5DX-83A-S <u>S E R V I C E N O T E</u>

5DX Series I, II, 2L, 3 and Series 5000 Systems

POSSIBLE LASER EMISSION HAZARD

August 31, 2005

Figure 1

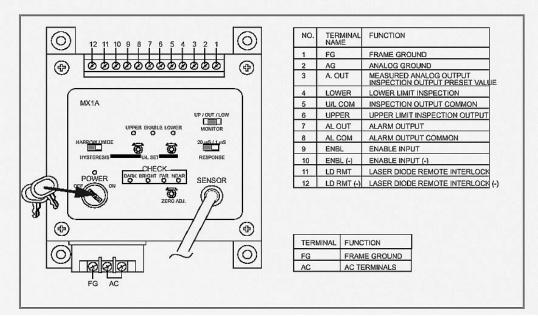
5DX Systems with two lasers installed will not function properly if the front laser to rear laser interlock jumper cable (E7200-61706) is mis-wired. The jumper wire being mis-wired enables the lasers to stay on all the time even if an access panel interlock is opened.

- 14) If either Laser Spot remained on, the laser did not turn off. This means that the E7200-61706 cable is mis-wired.
- 15) Turn off the Laser Power units by turning both keys to the off position.
- 16) Reverse the LD RMT(-) and LD RMT wires on one end of the E7200-61706 cable. See Figure 1.
- 17) Turn on the Laser Power units by turning both keys to the on position.
- 18) Continue with step 1.
- 19) Close the 5DX access panel.
- 20) Run Automatic Startup.
- 21) Unload C & A Panel.

Figure 2: N7200-84366 Service Note label installed at lower right of label area.

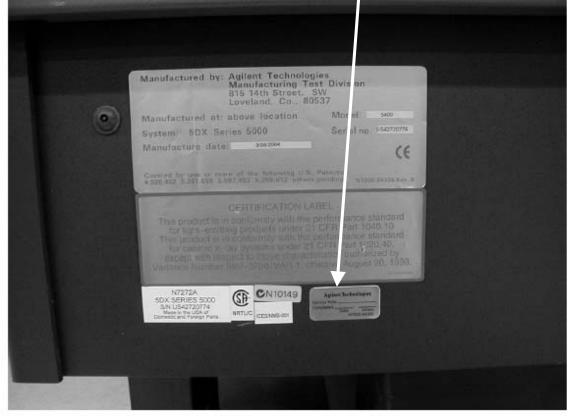
- 22) Upon completion fill out and install the Service Note label (Part Number N7200-84366) to the 5DX label area.
- Note the N7200-84366 label located to the lower right of the existing labels in the photo below.
